This document was prepared by Yong Kim and Geoff Garner.

Revision 8, November 7, 2011

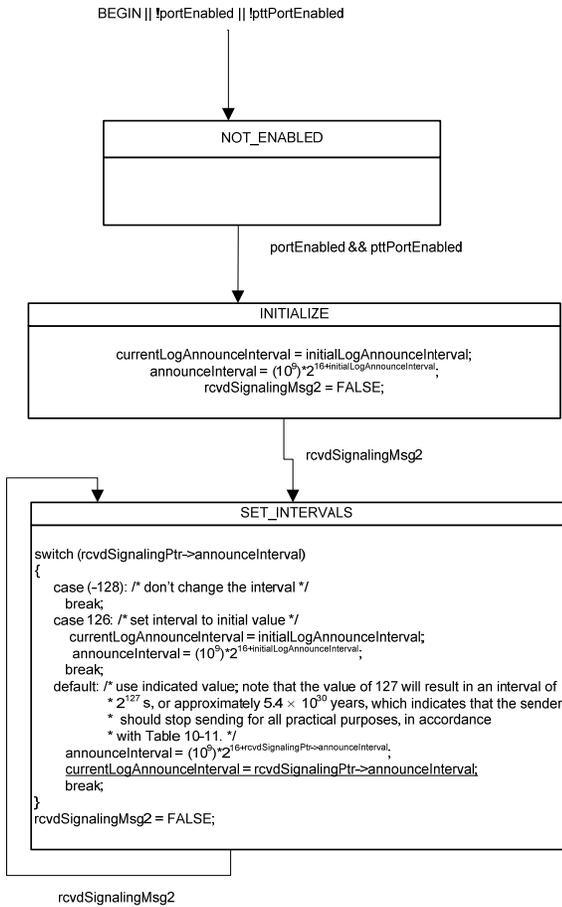
*Change the Figure of 10-16, as shown*

**Figure 11-2 – Transport of time-synchronization information**

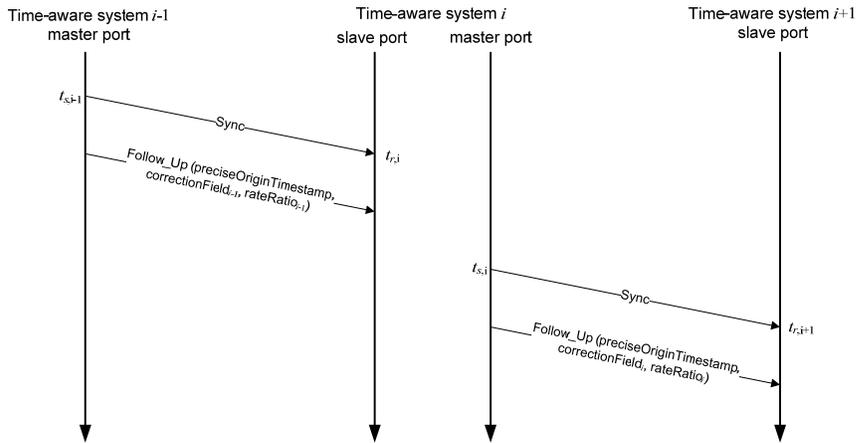
*Change the Text of 11.1.3, as shown*

The transport of time-synchronization information by a time-aware system, using Sync and Follow\_Up messages, is illustrated in Figure 11-2. The mechanism is mathematically equivalent to the mechanism described in IEEE Std 1588-2008 for a two-step,<sup>15</sup> peer-to-peer transparent clock that is syntonized (see 11.4.5.1, 11.5.1, and 11.5.2.2 of IEEE Std 1588-2008). However, as will be seen shortly, the processes of transporting synchronization by a two-step, peer-to-peer transparent clock that is syntonized and by a two-step boundary clock are mathematically and functionally equivalent.<sup>8</sup> The main functional difference between the two types of clocks is that the boundary clock

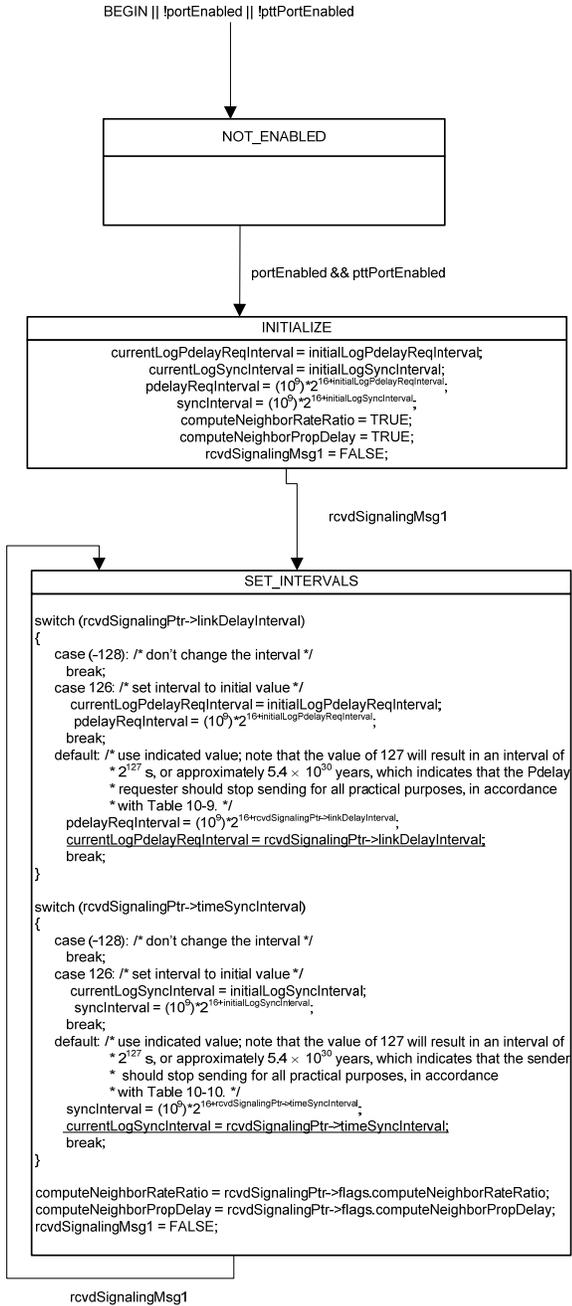
*Change the Figure of 11-10, as shown*

**Figure B.2 – ADEV limit corresponding to wander generation requirement of Figure B.1**

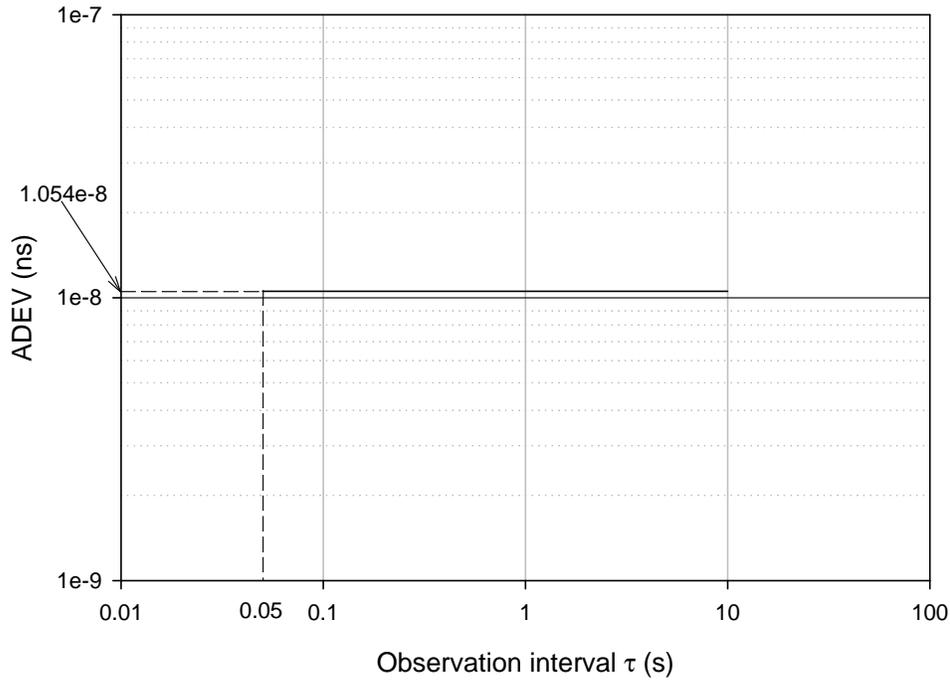
*Change the Text of B.1.3.2, as shown*

**Figure B.3 – PTPDEV limit corresponding to wander generation requirement of Figure B.1**

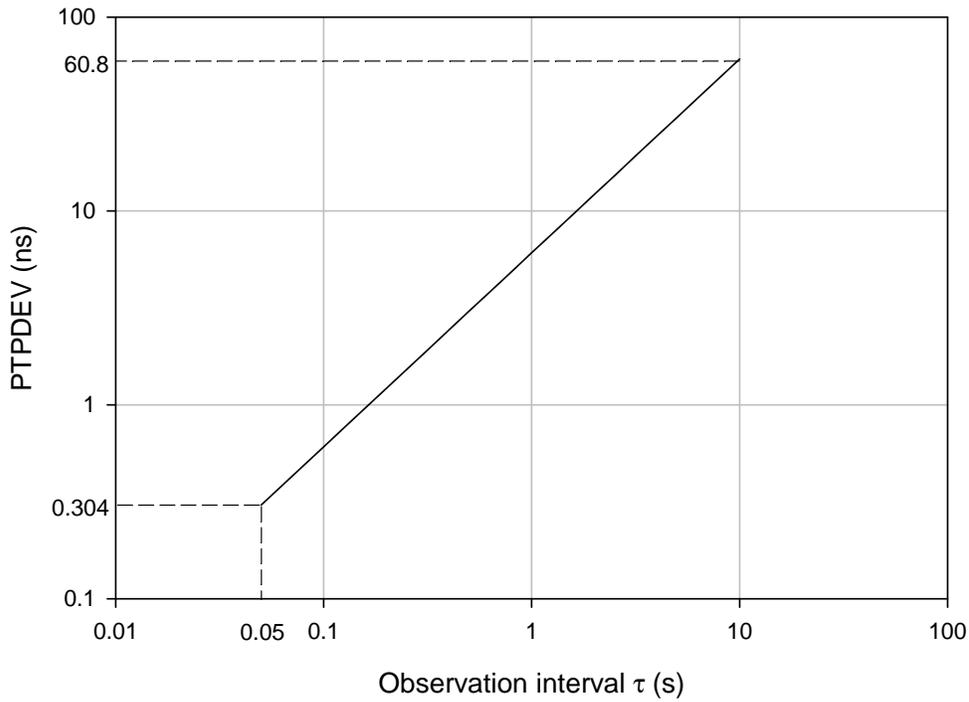
The PTPDEV limit that corresponds to the TDEV requirement of Table B.1 and Figure B.1 is shown in Table B.3 and Figure B.3, respectively.
